## Department of Procurement Services

### QUESTIONS AND ANSWERS

#### **IFB #081624VK – Dexter Elementary Roof Replacement**

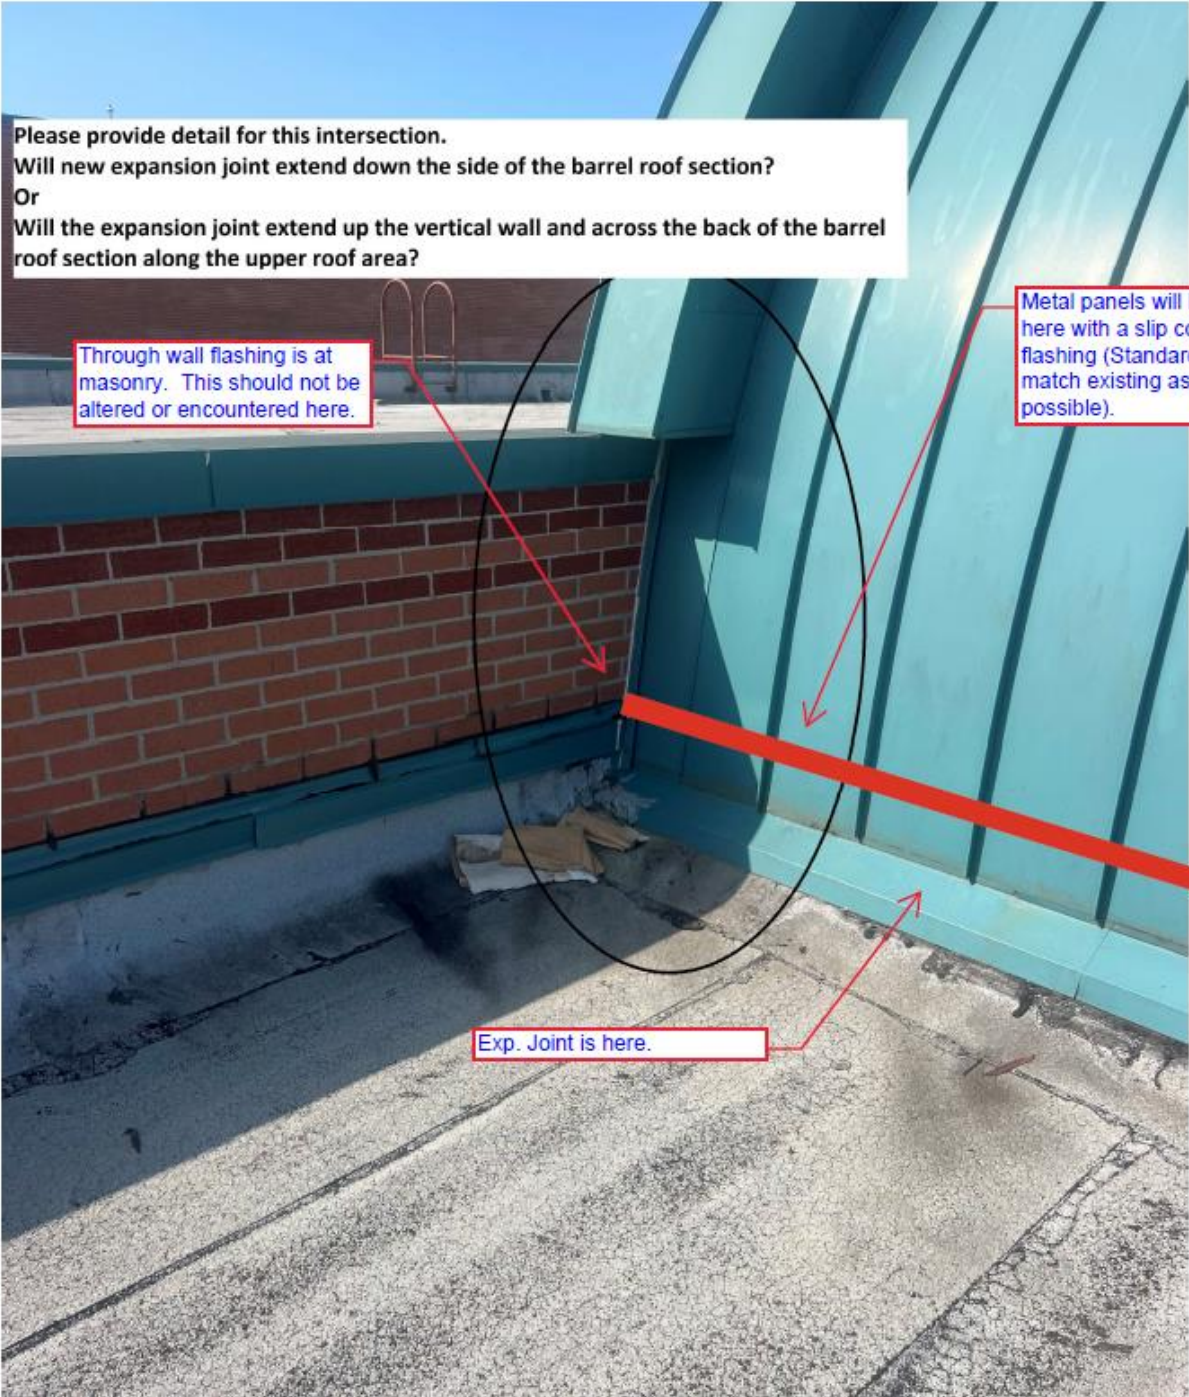
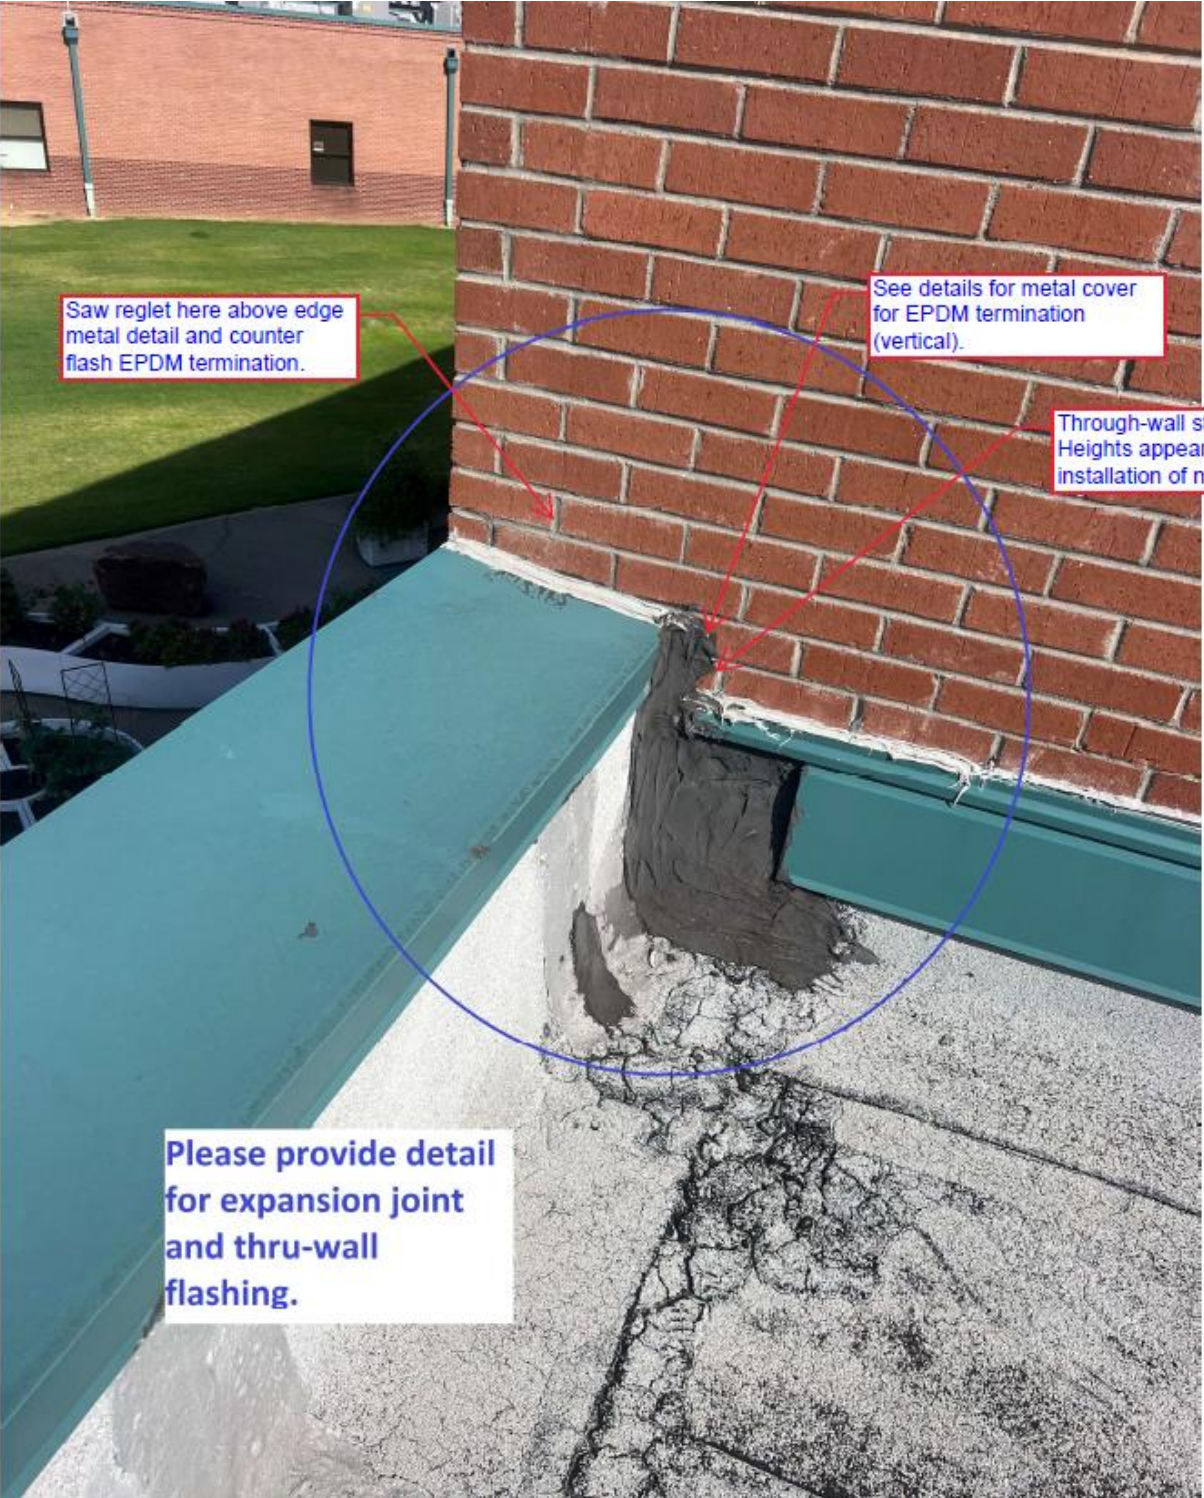
1. Please provide details for end-wall / thru-wall flashing conditions (see pictures)

**ANSWER:** See below comments. Details are provided on the drawings but not specific to these locations. Comments below for reference and clarification.

Saw reglet here above edge metal detail and counter flash EPDM termination.

See details for metal cover for EPDM termination (vertical).

Through-wall stops here. Heights appear to permit installation of new system.

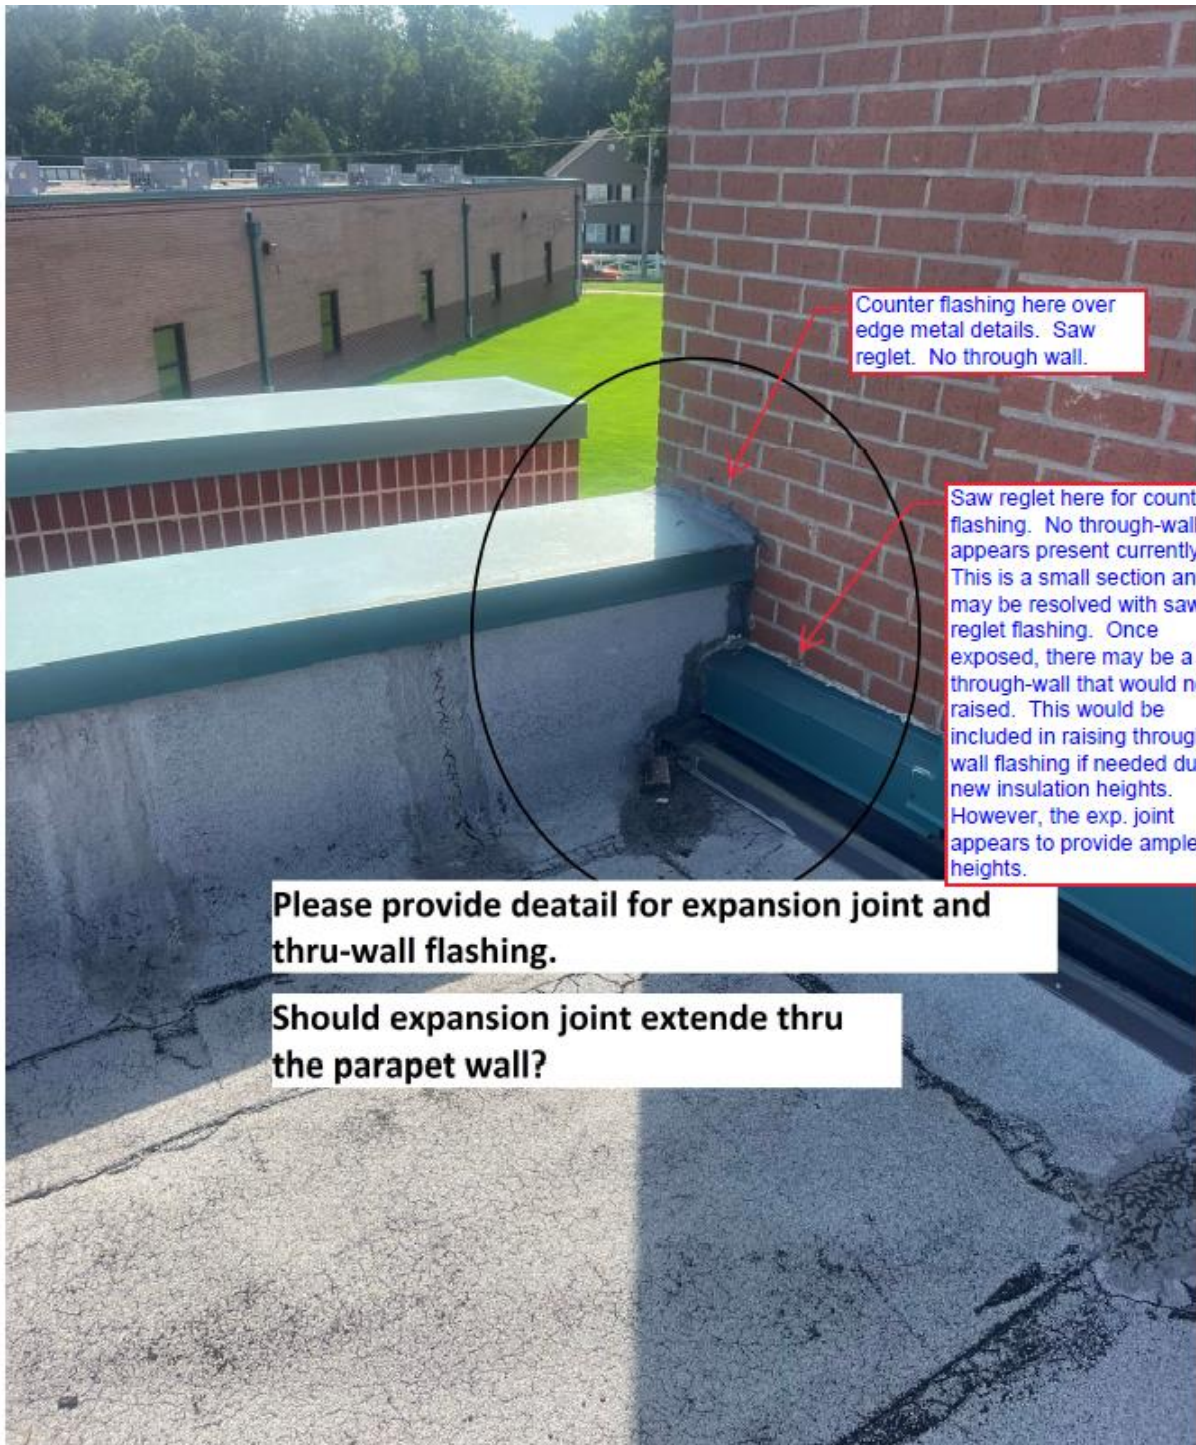
Please provide detail for expansion joint and thru-wall flashing.

**Please provide detail for expansion joint and thru-wall flashing.**

**Should expansion joint extend thru the parapet wall?**

Counter flashing here over edge metal details. Saw reglet. No through wall.

Saw reglet here for counter flashing. No through-wall appears present currently. This is a small section and may be resolved with sawn reglet flashing. Once exposed, there may be a low through-wall that would need raised. This would be included in raising through-wall flashing if needed due to new insulation heights. However, the exp. joint appears to provide ample heights.
